April 13, 1998

Subject: Addendum to Tier 2 RBCA Assessment
Former Oakland Tribune Site
2302 Valdez Street, Oakland, California
Alameda County LOP Site ID 3663
GA 125-01-02

DESIGNED BY:	CHECKED BY:	GROUNDWATER HYDROCARBON RESULTS, VARIOUS DATES FORMER OAKLAND TRIBUNE SHOP OAKLAND, CALIFORNIA	DATE: 02/2/98	FIGURE 5
DRAWN BY: JG	SCALE:		GRIBI Associates	
PROJECT NO 125-01-02

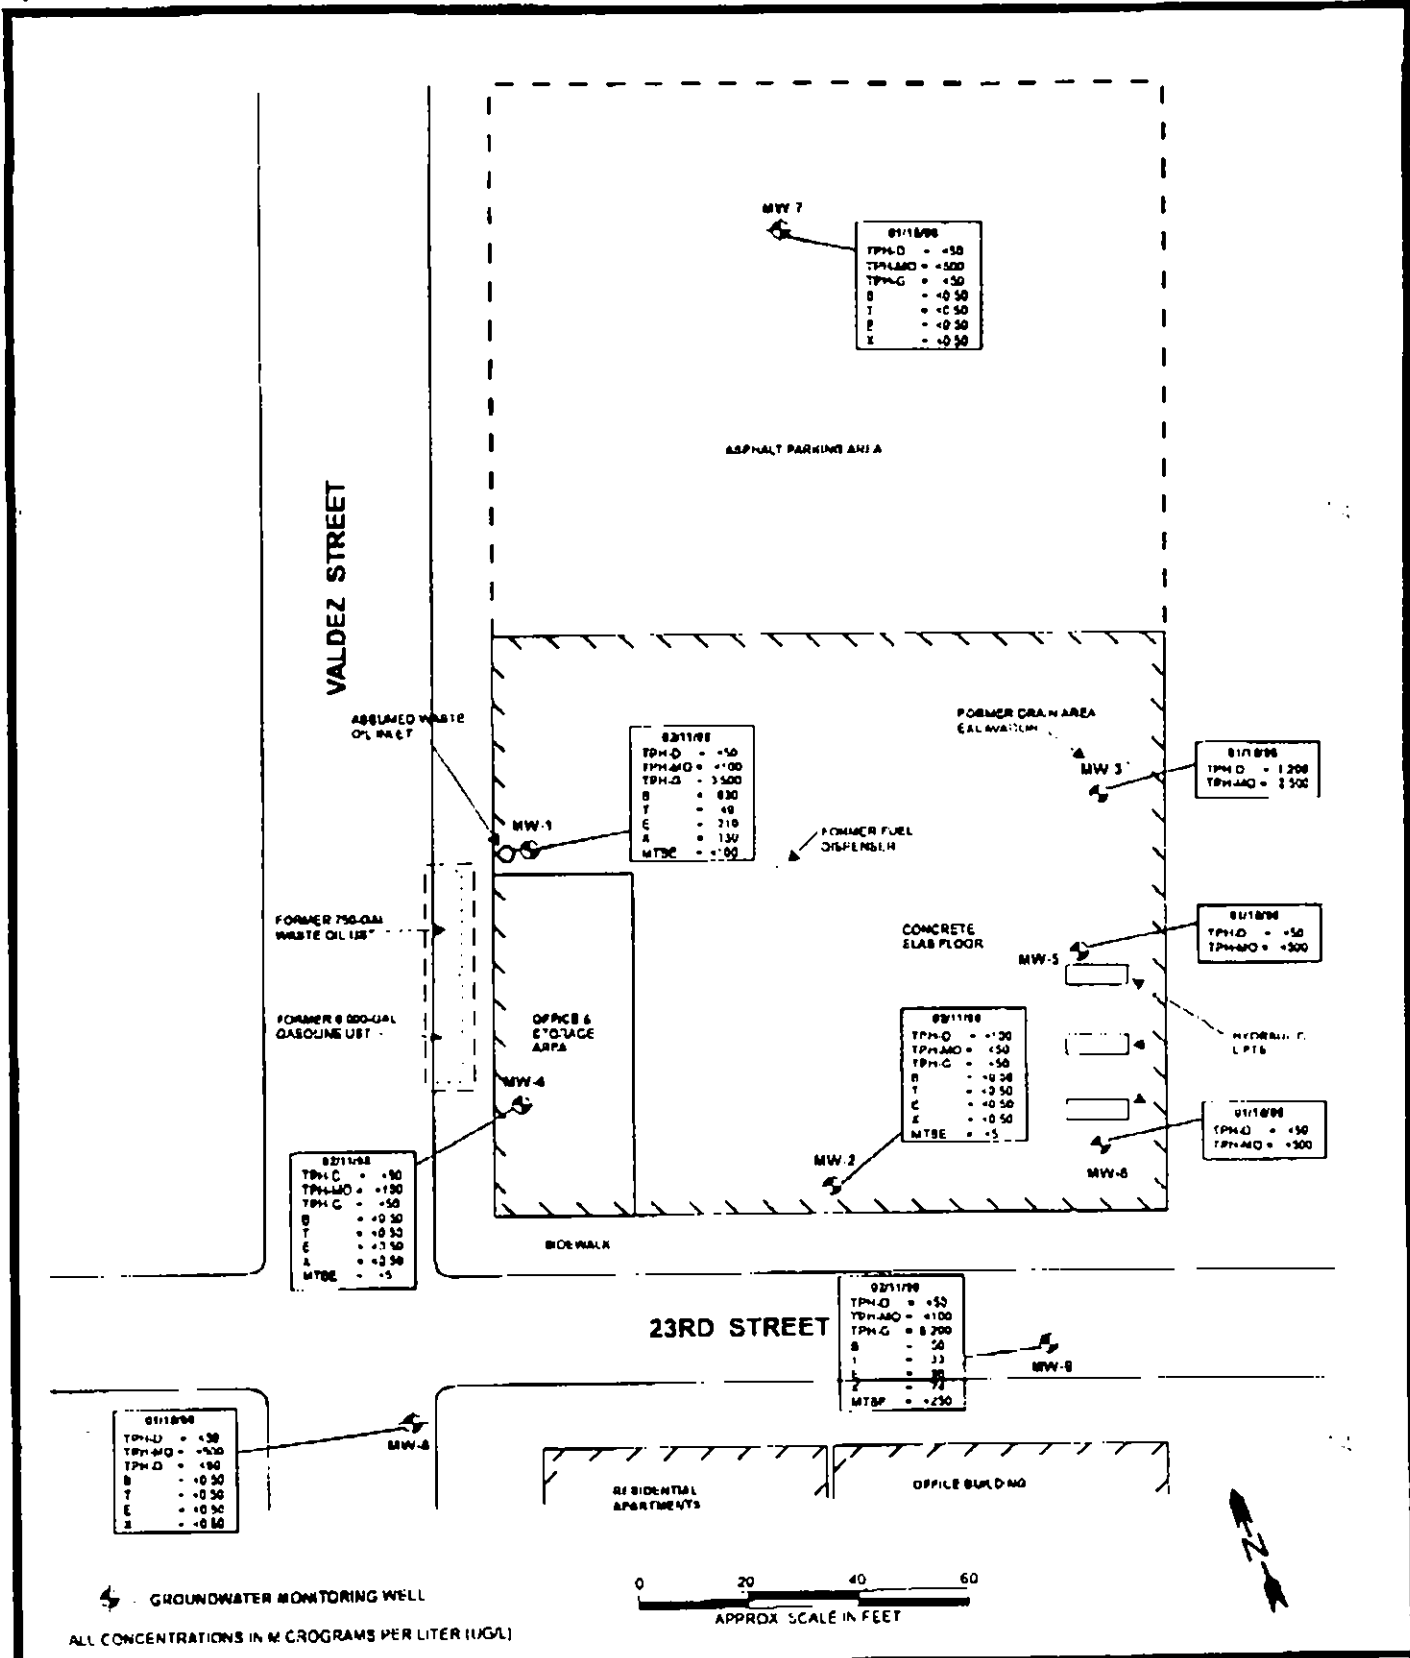
The closest identified potentially downgradient receptors are a residential apartment building and a commercial building, located across 23rd Street about 70 feet south and southeast, respectively, from the project site. A revised site plan showing the location of these buildings is included in Attachment B.
